DESIGN ADVISORY BOARD Tuesday, June 27th, 2017 at 3:00 PM Conference Room 12, City Hall, Burlington, VT Agenda

MEMORANDUM

To: The Design Advisory Board
From: Ryan Morrison, CFM, Associate Planner
RE: 55-57 Howard Street, ZP17-1280CA
Date: June 27, 2017

File: ZP17-1280CA
Location: 55-57 Howard Street
Zone: RL **Ward:** 5S
Date application accepted: June 14, 2017
Applicant/ Owner: PJ McHenry

① FRONT ELEVATION
1/4" = 1'-0"

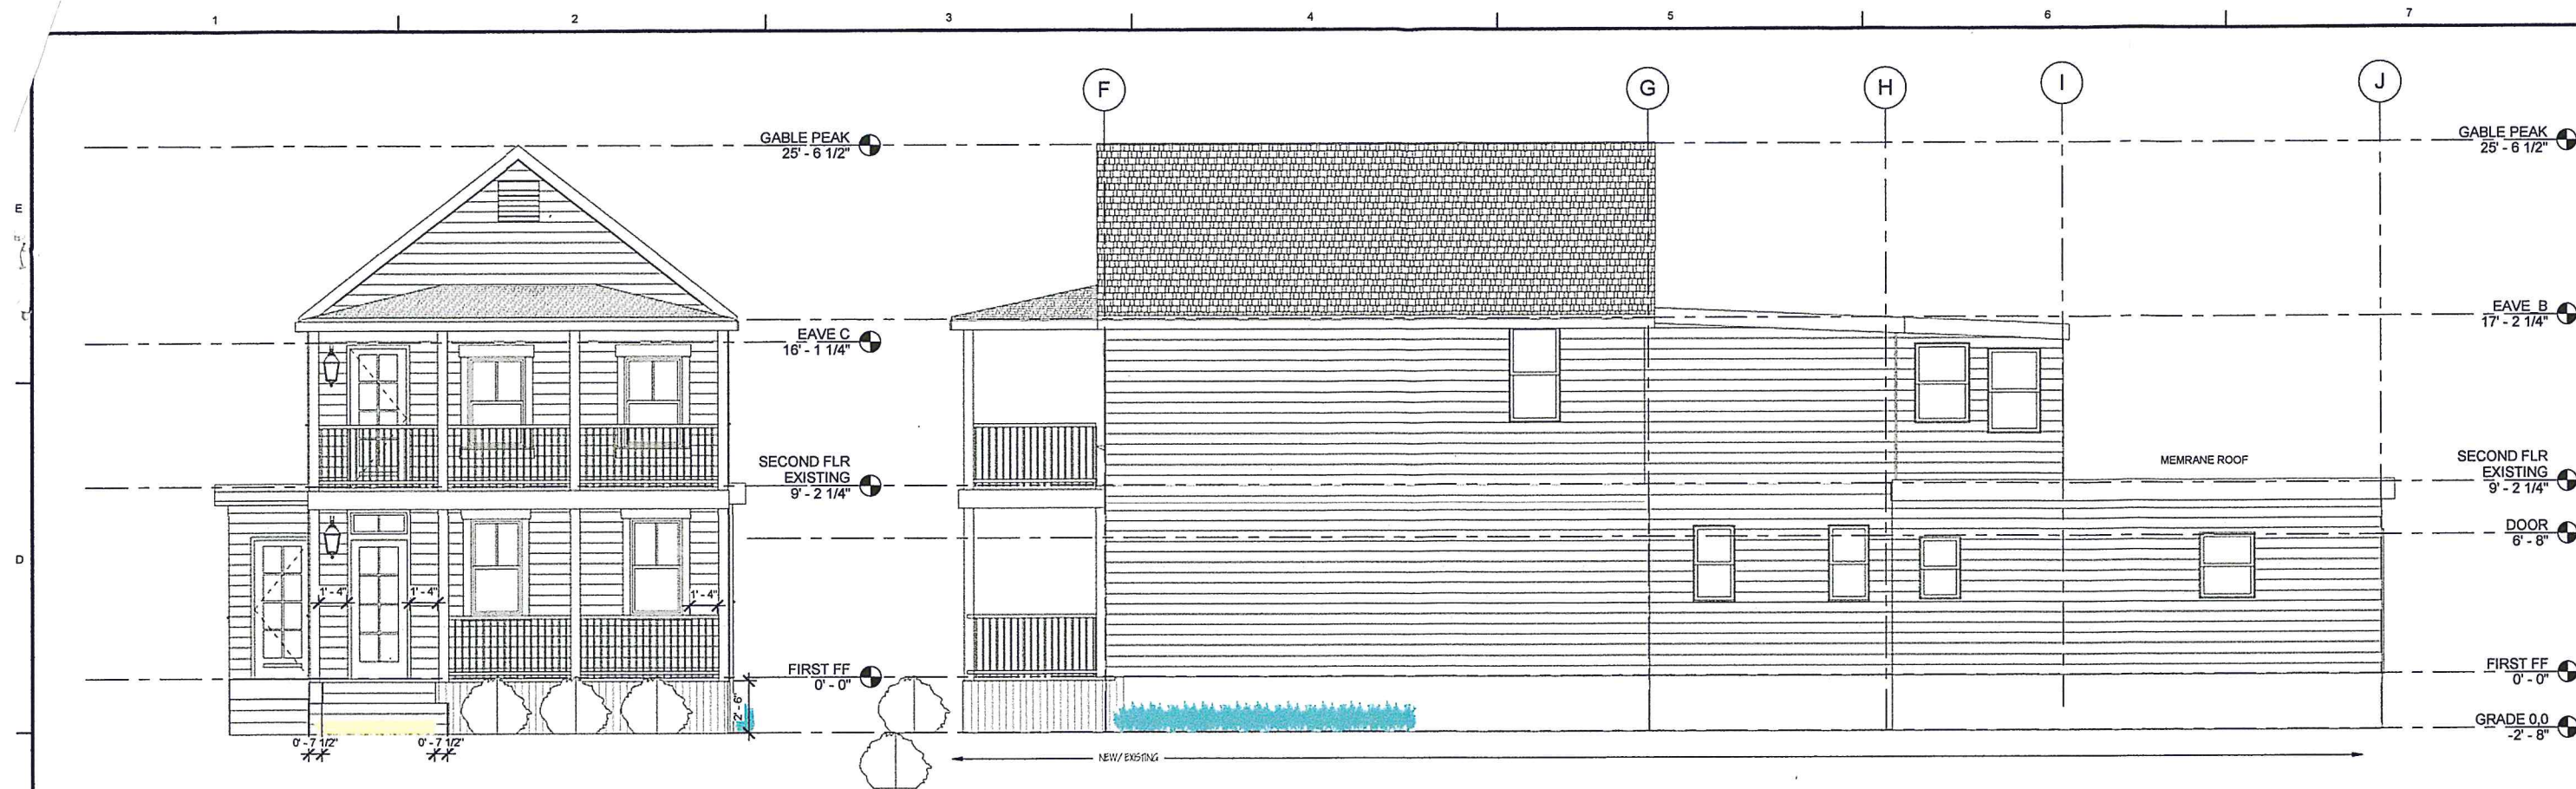
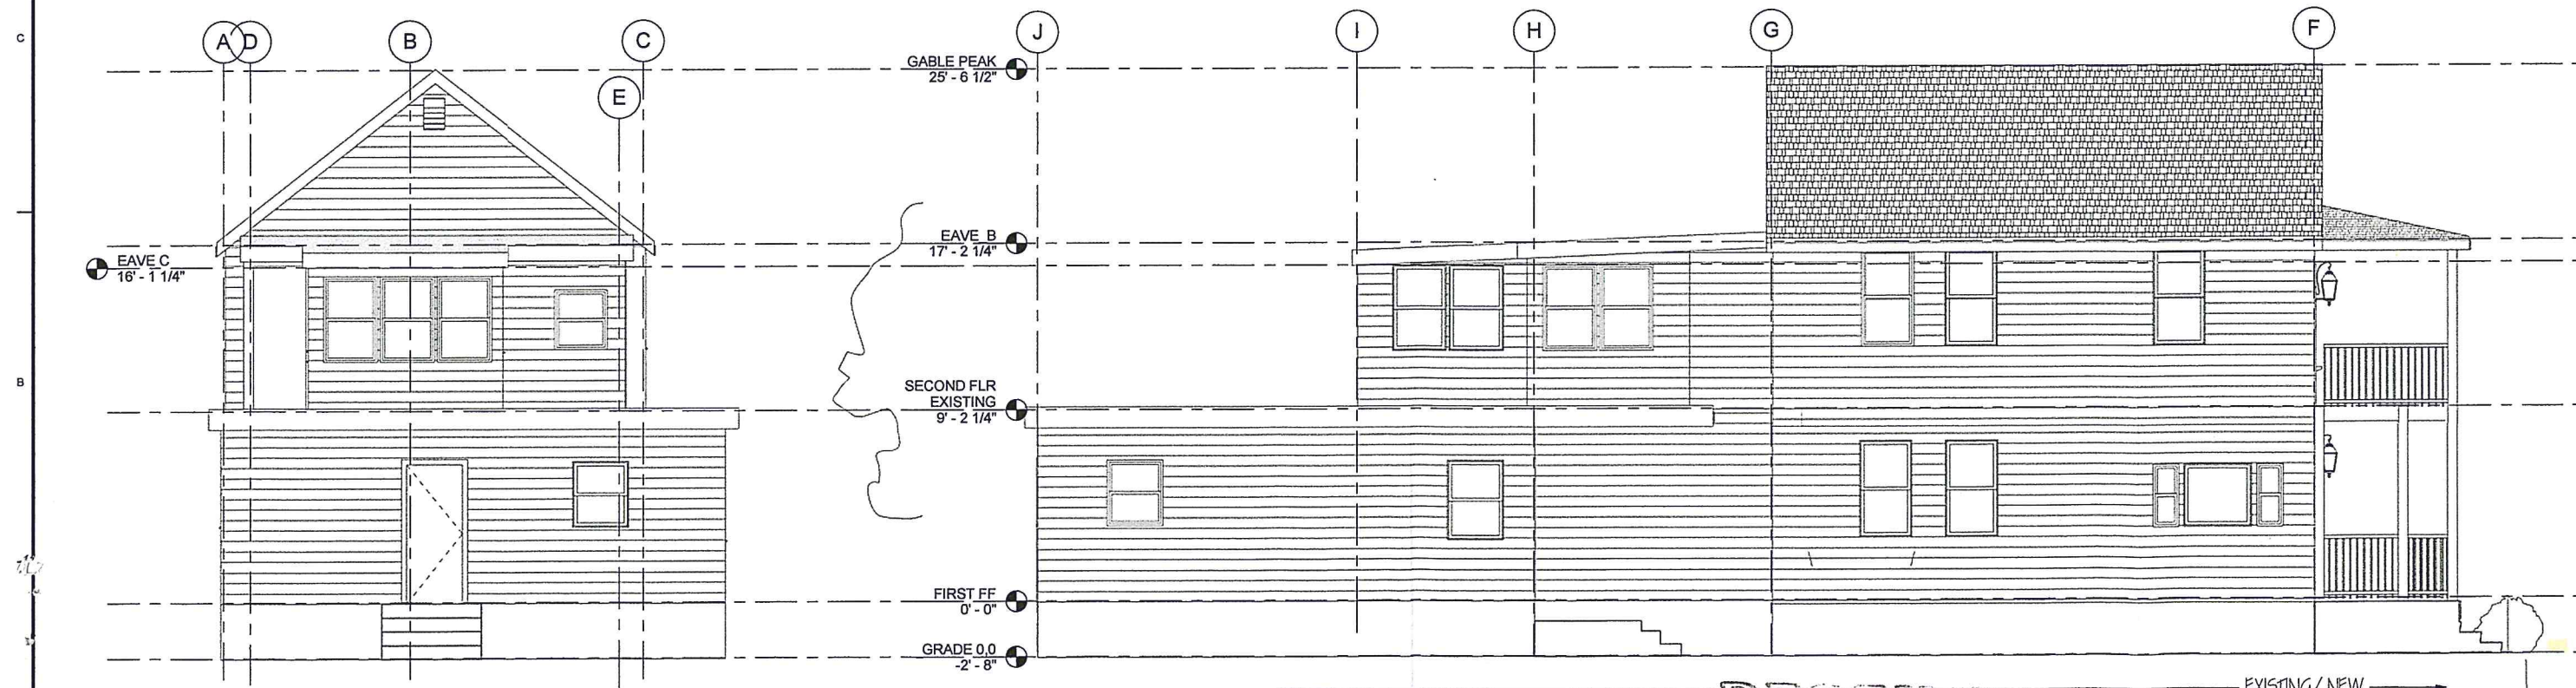
The front porch metal railings/spindles/posts (first story) also appear to be unoriginal. The current proposal will result in railings, spindles and columns take on a more historic appearance. However, based on previous practice, the use of pressure treated wood for the spindles, and for any other portion of the new deck, should not be allowed.

Exchanging the doors and easternmost windows (both stories) on the front façade may change distinctive façade spaces and spatial relationships. However, it may be that this would be of little concern, considering the changes to the structure over the years.

Exchanging the front doors and easternmost windows on the front façade (both stories) will still see a level of symmetry between the 1st and 2nd story front façade. However, as noted above, if the vinyl windows are at all altered, (i.e. relocated), they will have to come into compliance – meaning complete replacements with windows that correspond to the building's historic origins.

As proposed, the location of the entry doors and existing windows, on both stories, will be modified slightly. The centrally located 1st and 2nd story doors will swap locations with the corresponding easternmost windows. However, due to the fact that there are no zoning permits for the vinyl windows, they appear to be in violation. Any change to the vinyl windows, whether it be replacement or relocation, will require that they are changed to compliant wooden windows. Should the applicant elect to not relocate the vinyl windows, then feasibly they can remain as-is until such time that they need a zoning permit to replace or repair them. A future zoning permit will require that they be replaced with windows compliant with the historic nature of the structure.

The existing home is clad in aluminum siding. The new porch will consist of composite decking, and wood railings and posts. Approval of pressure treated spindles should not be granted due to the historic nature of the structure, and previous determinations that have ruled out use of pressure treated materials to replace historic features. The spindles should be made of material consistent with wood typically used on historic porches. The applicant proposes to install wood trim around the windows. The doors will be fiberglass, with wood frames, and 'half moon' transom windows.

1. The use of pressure treated materials shall be prohibited.
2. The double hung vinyl windows, if replaced or relocated, shall be replaced with wooden or clad wooden double hung windows consistent with historic preservation.

- The spindles on the replacement porch are to be square stock, non-pressure treated, with base and cap detail.
- The posts are to be non-pressure treated, square wood, painted posts.
- Any windows to be replaced are to be of a clad exterior, wood interior, 2/2 double-hung window.
- The replacement doors are to be therma-tru, ¾ light, with grille pattern detail, and one panel below.
